CHANCE
MANUFACTURING CO., INC.

Service Information

Ride: TWISTER

Subject: HEAD REST INSPECTION

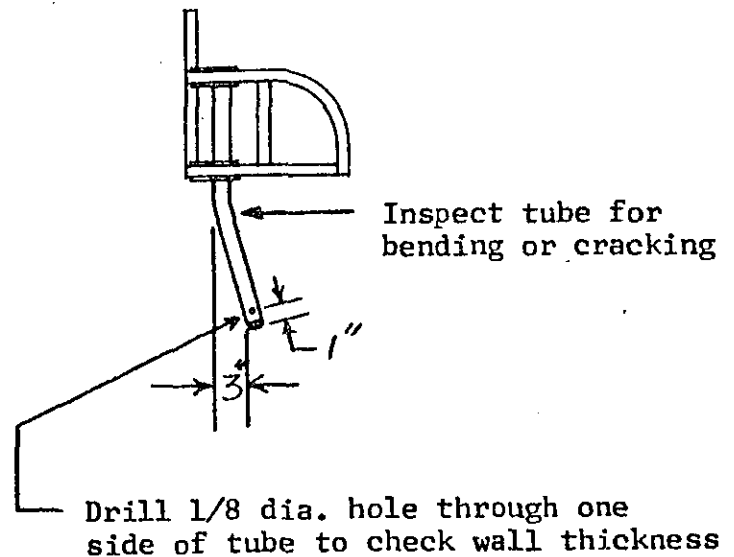
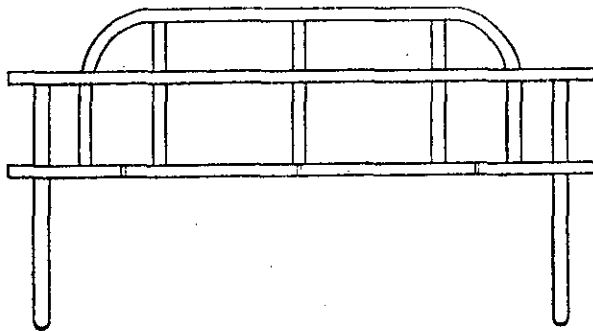
All TWISTER owners must inspect the head rests on all TWISTER cars immediately. Remove each head rest and inspect the support tubes that fit down in the sockets on each car. Inspect for any signs of physical damage, such as bending or cracking. Next, drill a small hole, 1/8 inch, near the bottom of the support tube approximately 1 inch from bottom. Drill hole through one side of the tube only. Check wall thickness of tube. It should be 1/8 inch thick.

If any of the tubes show signs of bending or cracking, or if any tube has less than a 1/8 inch wall, immediately report such condition to Mr. Richard C. Chance, General Manager, Chance Manufacturing Company.
